**Project: IEEE P802.15 Working Group for Wireless Personal Area Networks (WPANs)**

**Submission Title:** comment and resolution about CID 64 and etc.

**Purpose:** Contribution to IEEE 802.15.7 TG-VLC

## ❖ IEEE 802.15.4

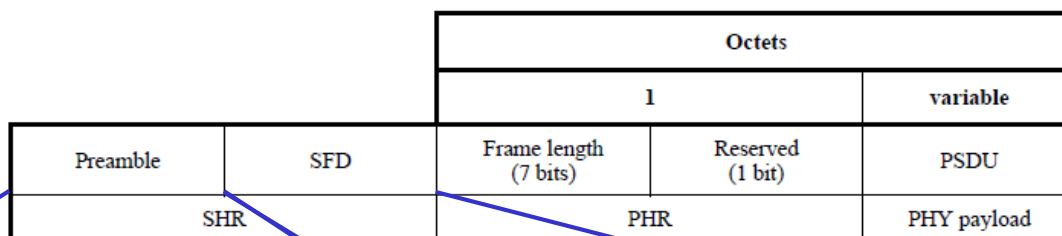
- (TR) §7.4.2, p. 163, l. 40–44: The phrase “where 6 represents ...” seems to be a remnant of the corresponding clause of the IEEE 802.15.4–2006 specification (where the PPDU has size 6 octets, viz. preamble: 4 octets; SHR: 1 octet; length: 1 octet). With 802.15v1c, the PHY header has variable size and contains more octets than with 802.15.4–2006. Suggested remedy: Correct the formula accordingly.

- Correct the formula accordingly.

$$\text{AckWaitTime} = \text{backoff period} + \text{turnaround time} + \text{clock period} * \text{numSymAckFrame}$$

- Where numSymAckFrame is the number of bits in the acknowledgement frame. numSymAckFrame = 12.875\*8 for PHY I & II and 13.875\*8 for PHY III. For B-ACK mode, the AckWaitTime would be larger, depending on the number of acknowledgements in the b-ack mode as explained in 7.2.2.2. The clock period is obtained via the optical rates specified in Tables 2 and 3.

- Replace formula with above equation and supporting text
